Appendix D 2800 Casitas Flood Risk Technical Memorandum, prepared by KHR Associates, dated October 9, 2020.

MEMORANDUM

Date: October 9, 2020
To: Ben Brosseau
From: James H. Kawamura, KHR Associates
Cc: Shane Parker, Parker Environmental
Re: 2800 Casitas Project DEIR - FEMA Response

LOS ANGELES RIVER
1% ACE FLOODPLAIN
FPMS REACH
GRID INDEX 8

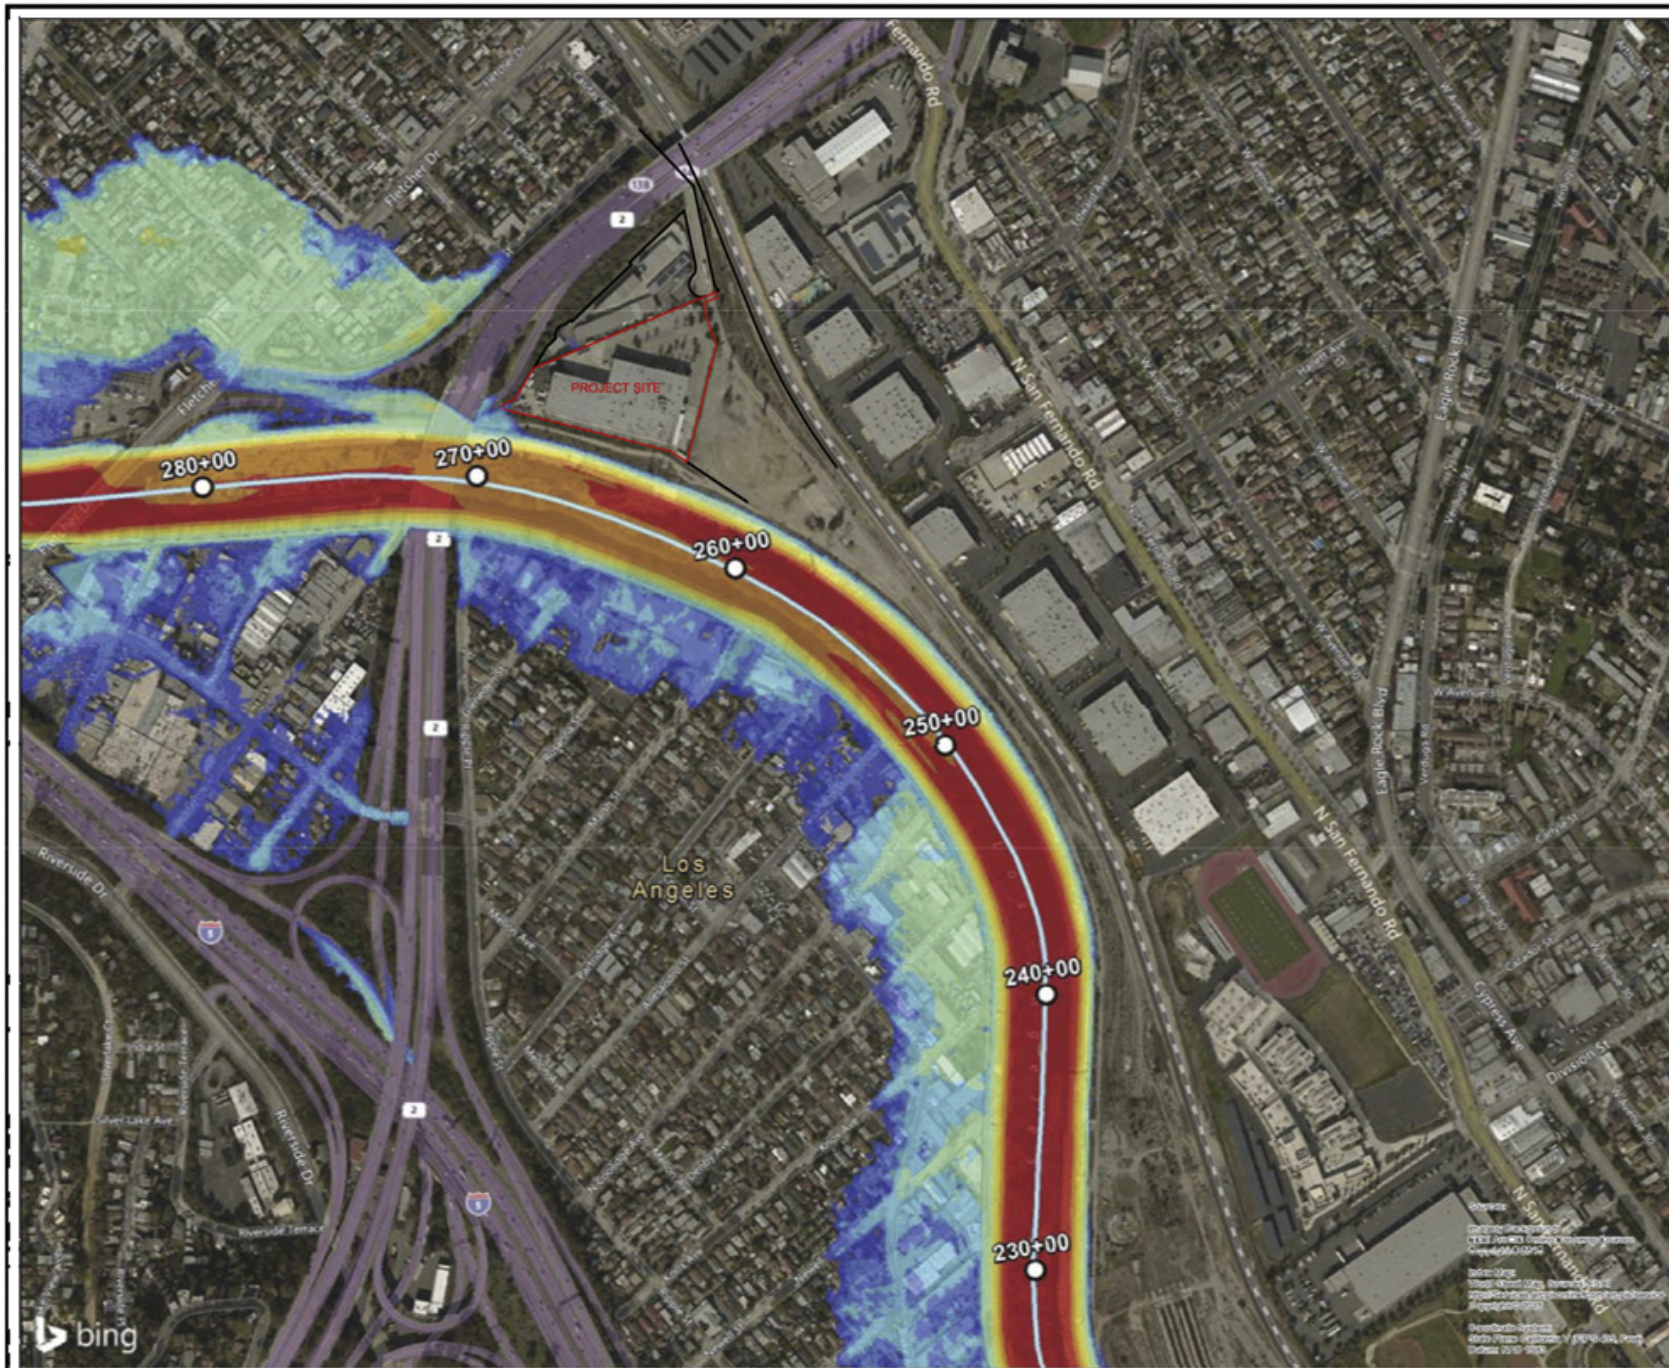
The Letter claims that the 2008 FIRM Maps “do not represent current conditions at the project site,” and that the 2016 Army Corps Report contrasts FEMA’s current position by claiming the Project site is shown in the Report to be subject not only to flooding, but inundation of 15 to 20 feet in the cases of 100-year and 500-year storm events. Two small exhibits taken from portions of the full exhibits contained in the Army Corps Report are referenced in the Letter. The scale of the exhibits in the Letter are presumed to be the same as in the actual Report (i.e., 1 inch = 500 feet).

Given the scale of the exhibits, it cannot be determined with any certainty that a small corner of the Project is currently within the 1-percent ACE floodplain. As for the 0.2-percent ACE floodplain, the Army Corps model suggests that some portions of the Project site, as it currently exists, could be inundated with 1 to 2 feet of water in a 500-year storm event and some portions could be inundated with 3 to 5 feet of water.

Based on a topographic survey of the Project site (see attached ALTA/NSPS survey by KHR Associates), existing mean elevations range from 365.7 to 368.9 feet above sea level. The southwest corner of the site is at the lowest elevation of 365.7 feet above sea level and is in the area that is claimed in the Letter to be within the 100-year flood hazard zone. Additionally, the 500-year flood exhibit, as shown in the Letter, seems to cover much of the property, except for the southeastern corner of the site where the existing elevation is over 368 feet. It should be noted that there is also an 8-foot high berm (or levee) that separates most of the Project site from the banks of the Los Angeles River, with a high point of 376.4 feet.

The Project Development Plan will include raised elevations above both the 100-year and 500-year flood levels. Building finish floors will be constructed at elevations of at least 369 feet and perimeter roadways and other at-grade surfaces will be raised to approximately 368 feet, more than two feet higher than the lowest existing elevation in the southwest corner of the site. The net effect will be that the entire Project site is not expected to fall within either a 100-year or 500 year storm event.
